Inspection Report
Vintage Eastside
688 East 16th Avenue

Re: Vintage East Side, Strata Plan LMS 3868
688 East 16th Avenue, Vancouver B.C.
- 1 Year Deficiency Review - Deficiency List

Re: Strata Plan LMS 3866, Vintage East Side
688 East 16th Avenue, Vancouver, B.C.
- 1 Year Deficiency Review

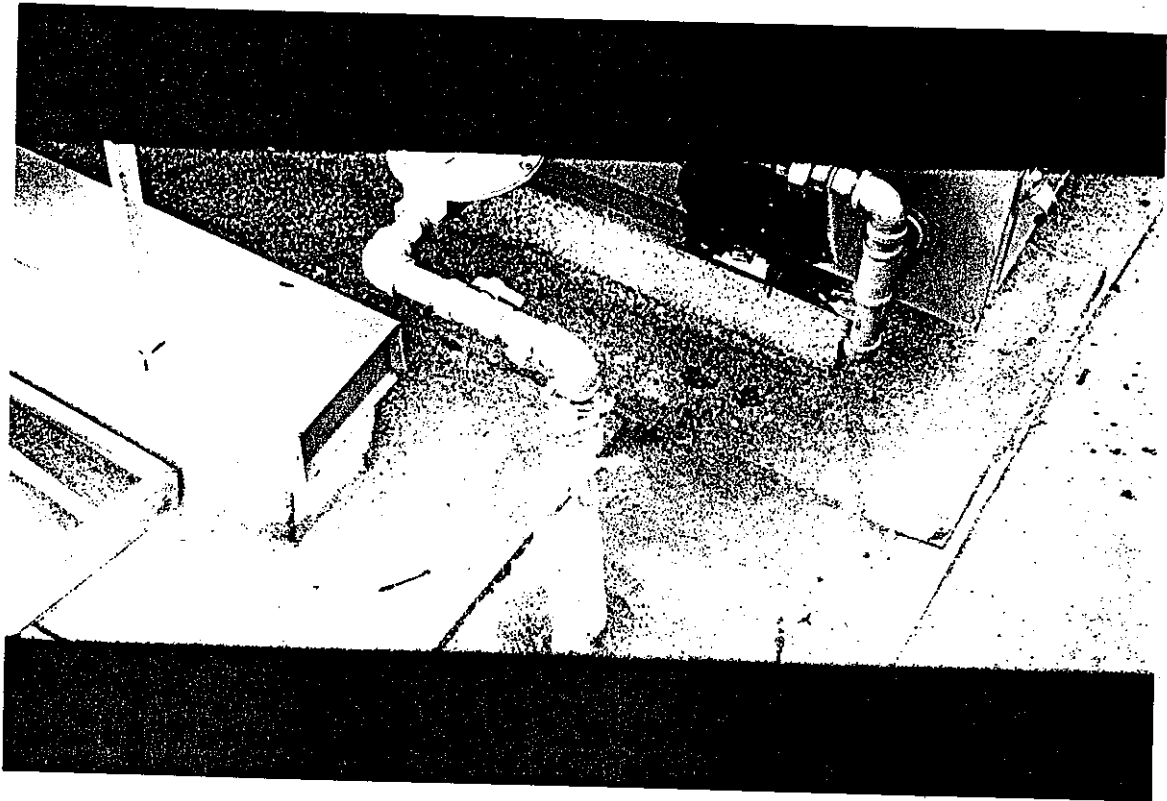
NEED CAULKING

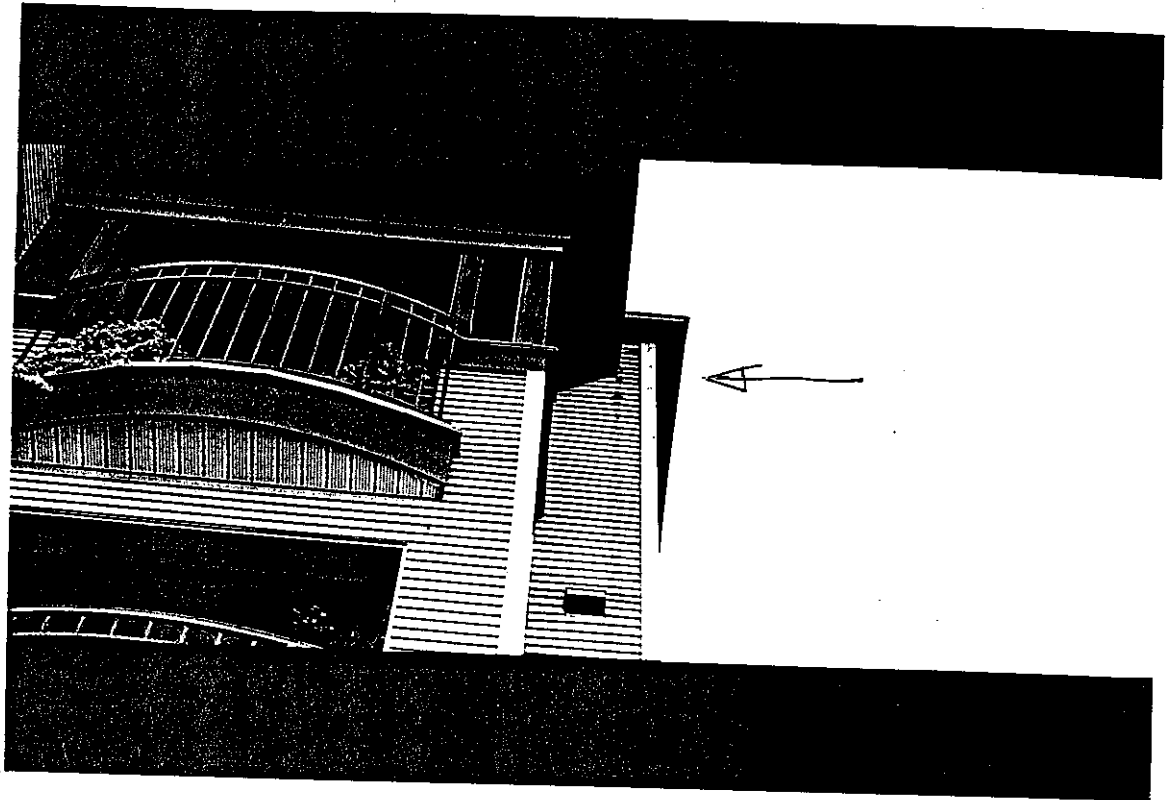
GUTTER OVERFLOW — STAINING

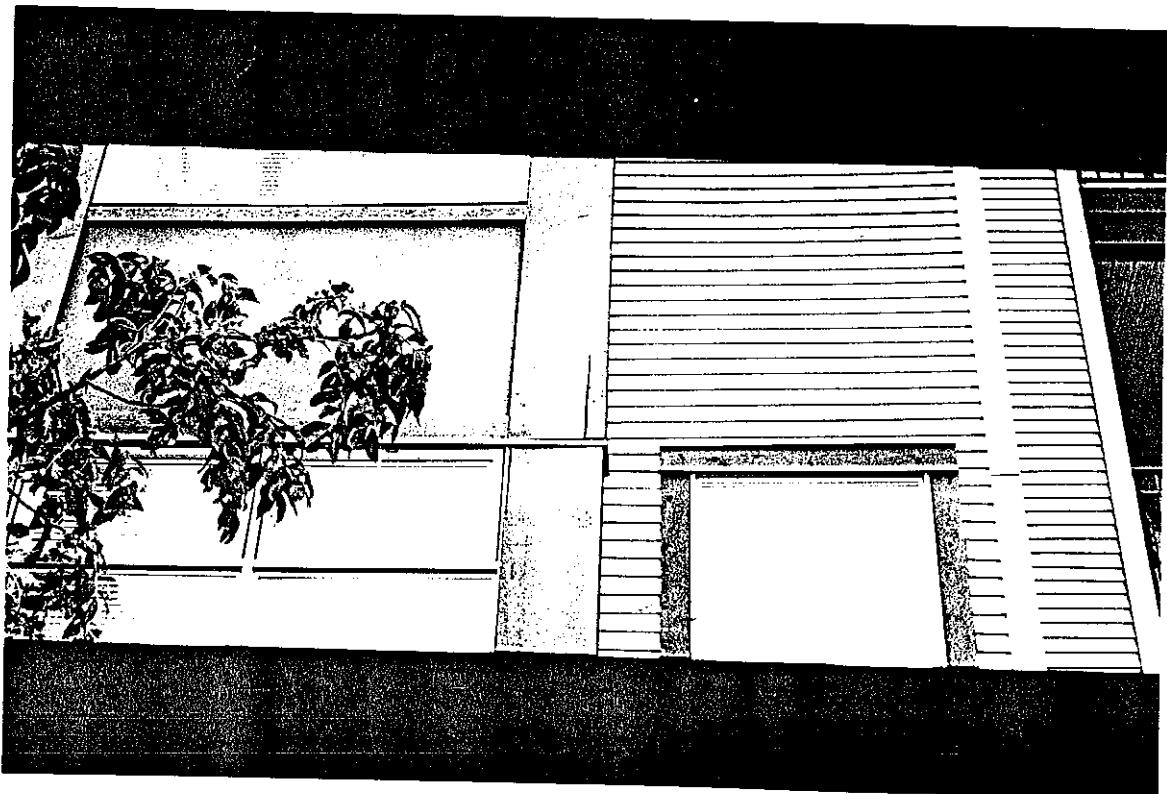
SIDING CRACKS

WILL BE FINISHED IN MAY/4
(BY CAROL CONSTRUCTION)

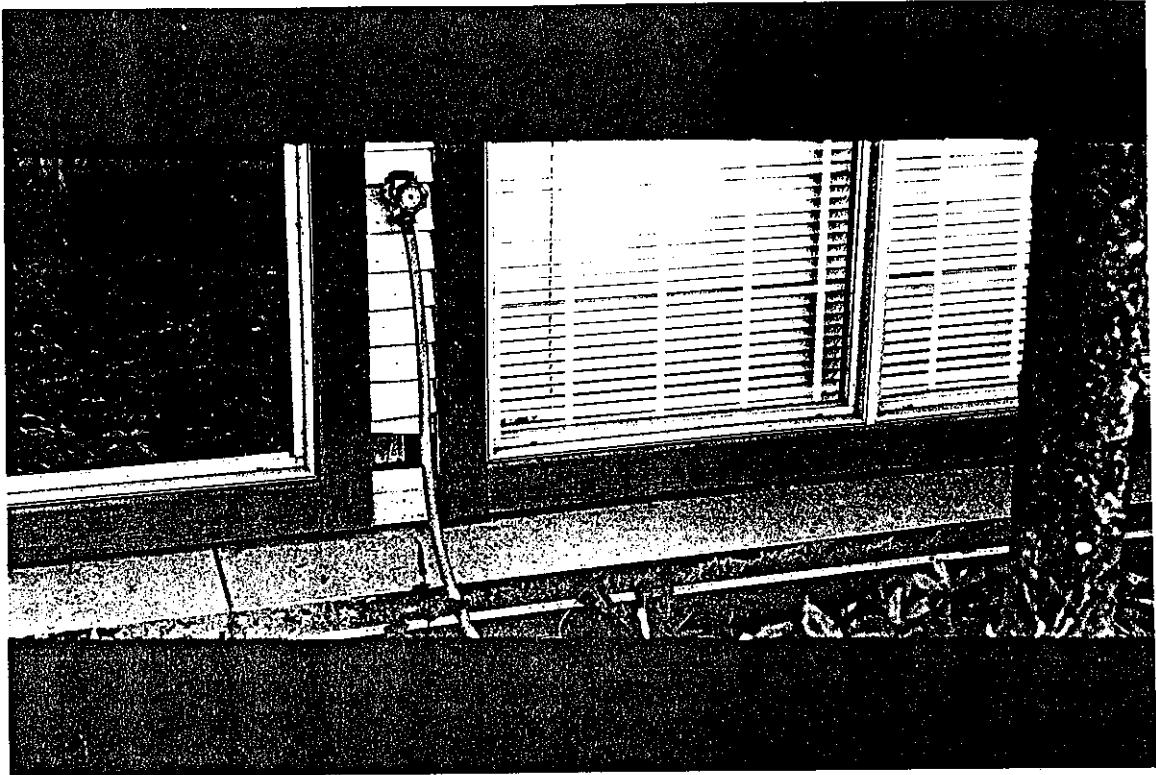
MISSING SIDING

| 1) | repair to missing siding in walls near hose bibs | \$ 500.00 |

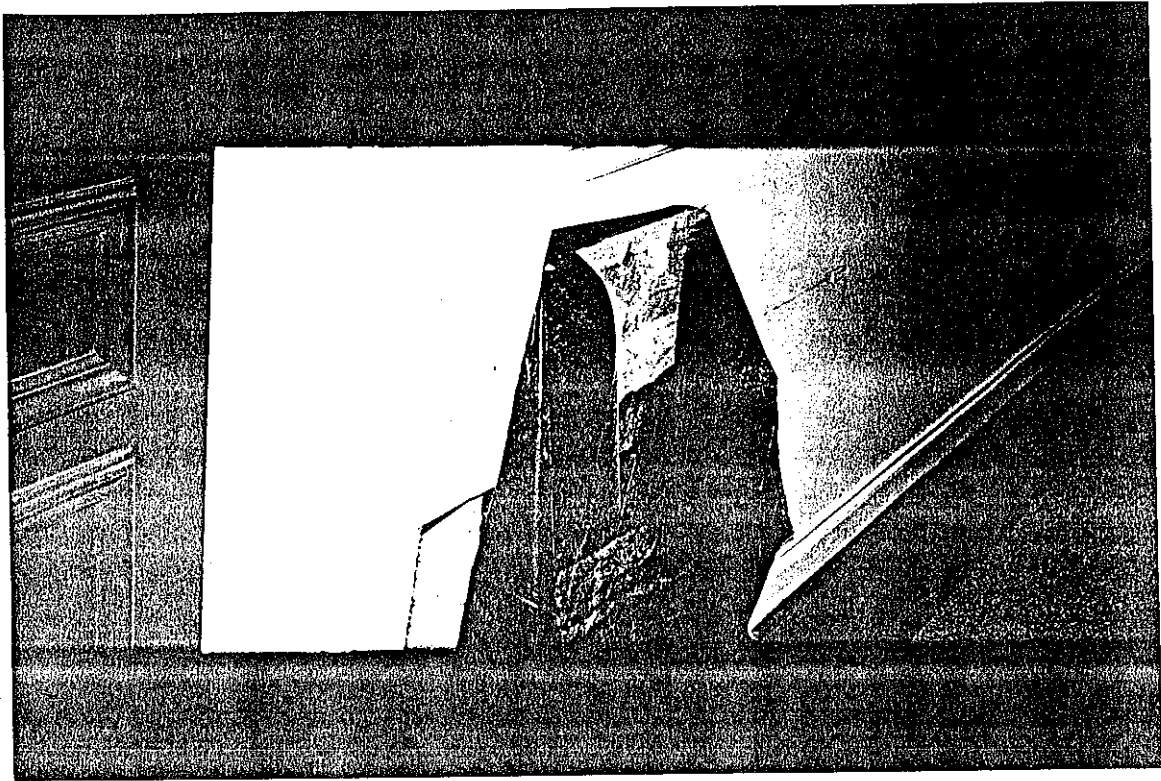
5.0 First floor hallway shows repair work going on. This needs to be completed.

HALLWAY WORK — NEED COMPLETION ✓
by 11:00 AM
2000

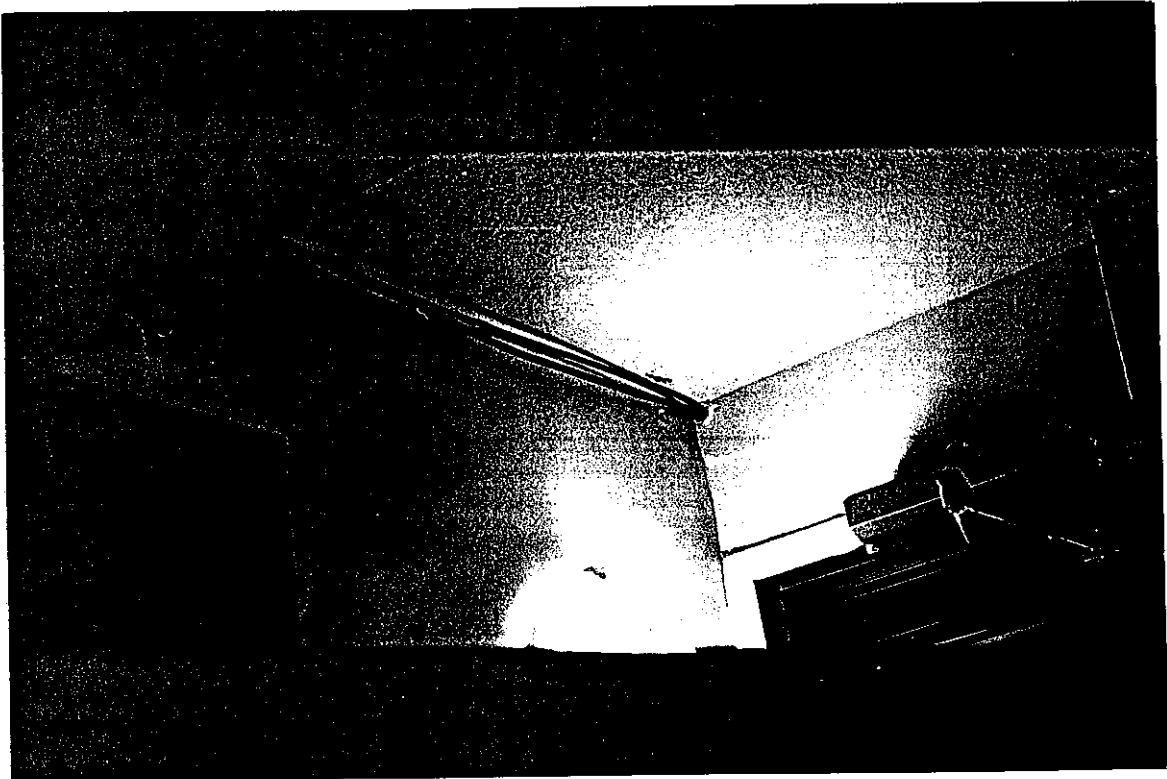
EXPOSED WIRES

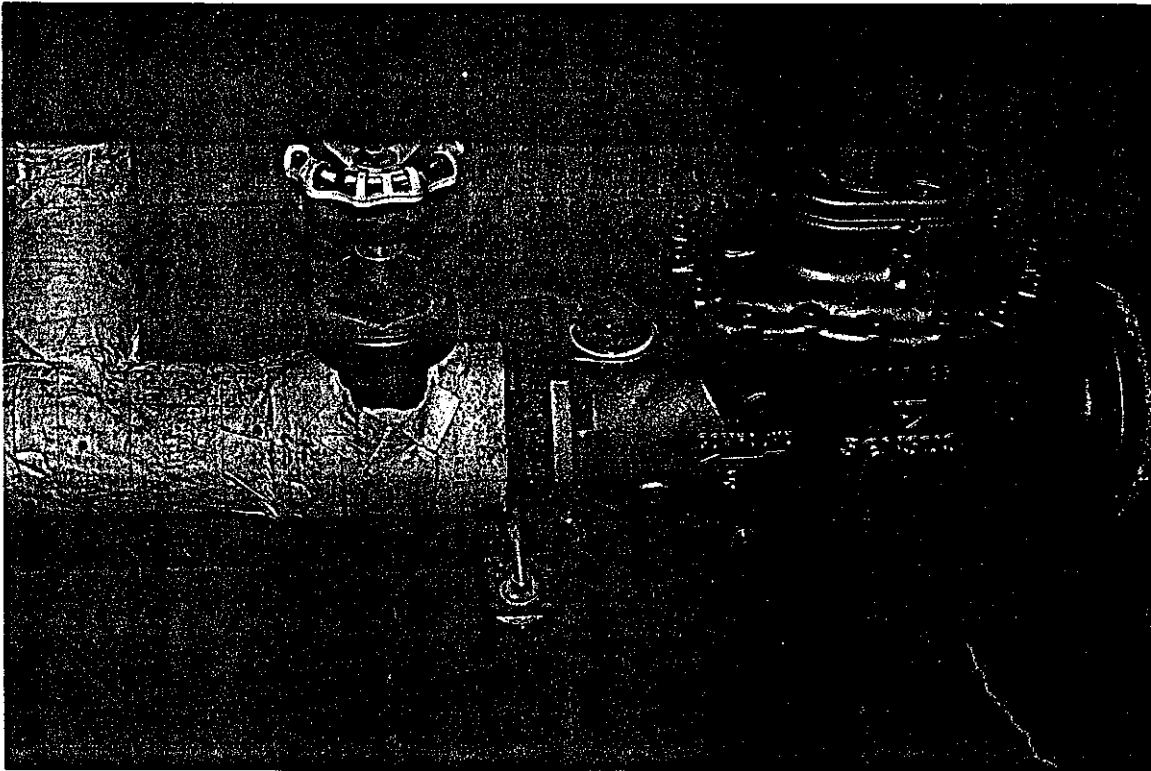
NEED PAINT - RUSTING

Photo # 3

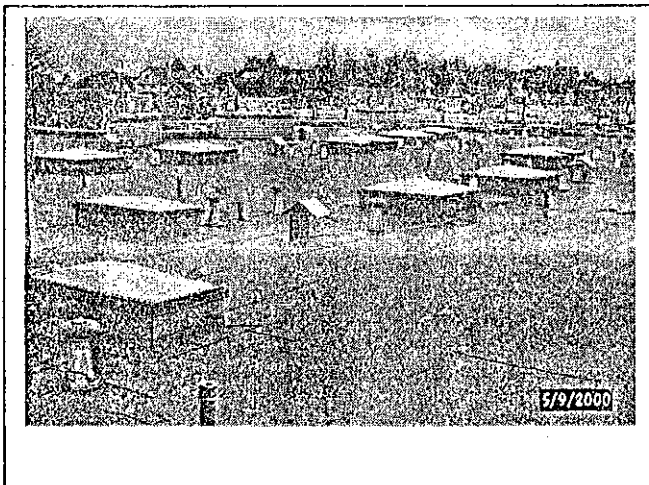
- .1 The waterproofing protecting the top floor of the building is modified asphalt "torch on" membrane assembly, with a slate granule finish.
- .2 The architectural plans describe a 2 ply-SBS membrane assembly applied to the sloped roof decking.
- .3 The membrane for the most part is adequately and properly installed, in accordance with current roofing and building envelope practice.
- .4 The roof deck has been adequately sloped to the roof drains however, there are small areas that have standing water on the membrane surface.

Typical roof membrane, showing minor standing water.

- .6 Minor ponding water on flashings and the membrane is not a concern with this type of membrane assembly.

Photo # 7

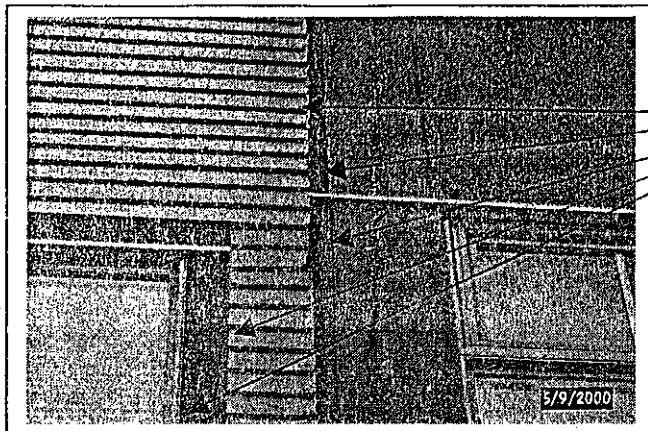
- .1 As noted there are many open joints and gaps in the cladding assembly that have not been caulked or sealed. These may permit moisture to penetrate the siding and contact the sheathing paper.

Typical non-sealed gaps or opening in trim boards that may permit water penetration.

Photo # 9

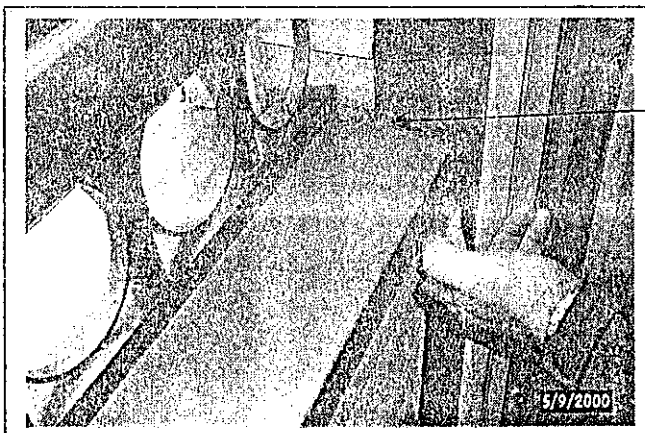
- .4 The cap flashings and through-wall flashings have not been fabricated with end-dams or continuous welded flanges at the termination locations also referred to as saddle points. The City of Vancouver Bulletin 96-02, which was issued on July 30, 1996 and came into effect on September 1, 1996, specifically indicates that these flashing details are often overlooked, and states additional emphasis must be placed on "the provision for field fabrication and welding at three-dimensional connections"

Typical saddle flashing detail that does not incorporate an up-turned flange behind the cladding.

- .1 The most significant concern is the absence of three dimensional saddle flashings. Although there is a membrane underlayment we are not able to verify the integrity or complete installation of the same. We recommend these areas be closely monitored for any signs of water ingress problems.
- .2 Decks surrounded by high up-stand walls as opposed to open railings must have a primary drain as well as an over-flow drain. This is to prevent the back up of water on the decks should the primary drain become blocked. Some decks do not appear to have overflow drains.

Photo # 13

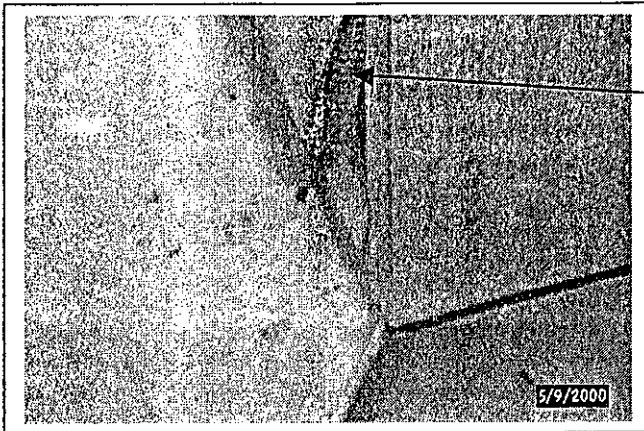
- .3 Wood siding or trim that is not fully back-primed or painted may cause several different problems. The wood siding will absorb moisture through the unprotected surface of the panel. Thermal cycling can cause moisture in the siding to permeate to, or through, the exterior paint. This in turn may cause a premature failure of the surface paint.

Typical non-primed cut end of wood siding.

Photo # 14

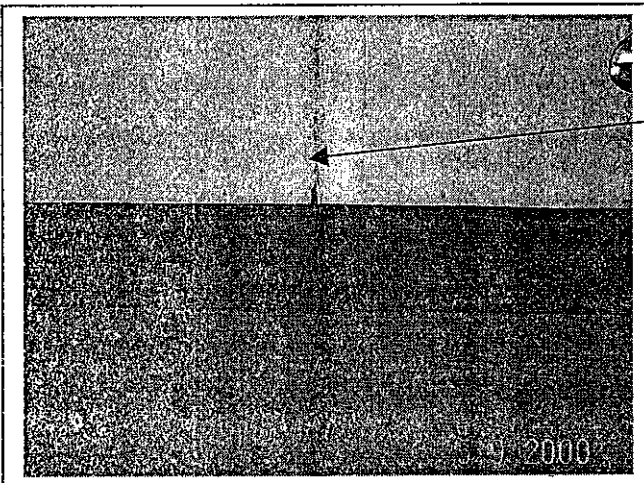
- .3 Leakage evidenced by rust coloured efflorescence in a vertical crack (adjacent to vertical reveal) and diagonal crack from corner of slab-band parking stall # 1.

- .1 The parking area is displaying signs of minor leakage problems. It is difficult to tell whether the staining caused by the water ingress is current or whether it occurred during construction. The weather at the time of our examinations was overcast and raining.
- .2 Defects in the slab membrane or below grade damp-proofing are extremely difficult and costly to resolve. This is primarily due to the excavation of landscaping and backfill covering the membrane or damp-proofing in order to gain access to the same.
- .3 Complete repairs will require excavation of the fill above the affected area to access the membrane or damp-proofing and complete repair or replacement of all defective areas.

Water staining and efflorescence visible on wall of parking garage.

- .4 An alternate method of addressing the leakage which may be considered is urethane crack injection. This will effectively stop leakage only through the cracks where it is applied. Water migration past the membrane or damp-proofing will not necessarily be stopped, and other cracks not currently exhibiting signs of leakage may begin to leak.
- .5 The architectural drawings and design describing the slab membrane are consistent with current building science practice.
